Revised Minnetonka Boulevard design maintains Inglewood Avenue access

Revised preferred design

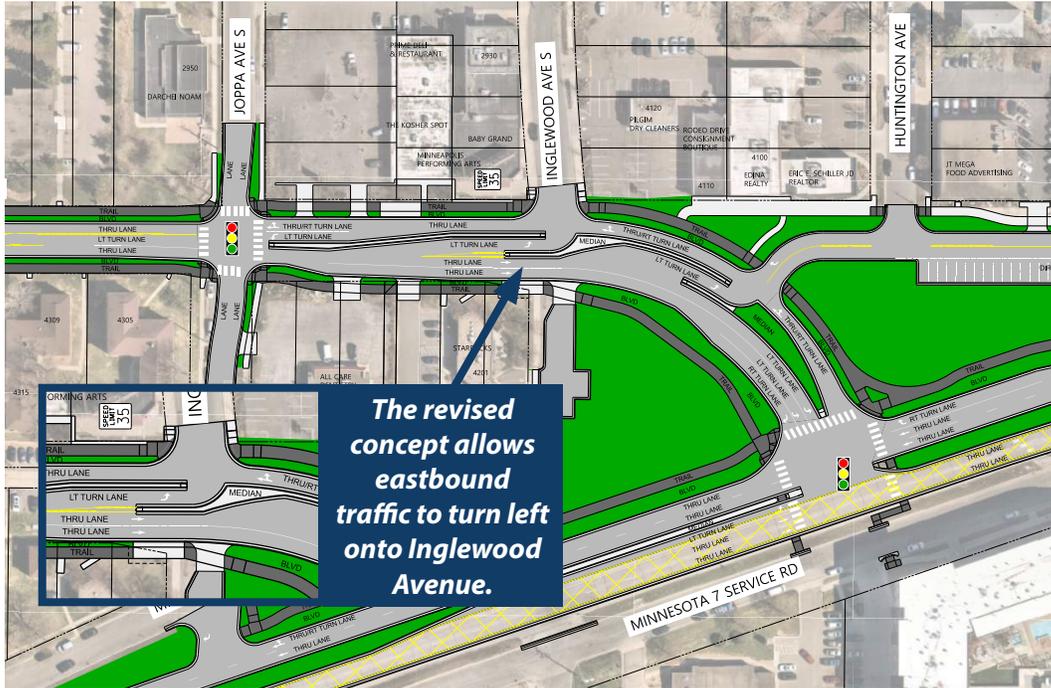
- Restricting left turns onto Inglewood Avenue would increase traffic on Joppa Avenue. This could impact the effectiveness of the pedestrian enhancements made to the corridor.
- Joppa Avenue only extends two blocks north, requiring northbound traffic to re-route east to continue heading north.

To address what we heard, the project team redesigned the Minnetonka Boulevard/Inglewood Avenue intersection to allow eastbound left turns. This change in the preferred design:

- Directs less traffic onto Joppa Avenue, reducing the potential impact of increased traffic on the safety of people walking, biking and rolling in the area, including students traveling to nearby schools.
- Maintains Inglewood Avenue as the preferred access route north of Minnetonka Boulevard.
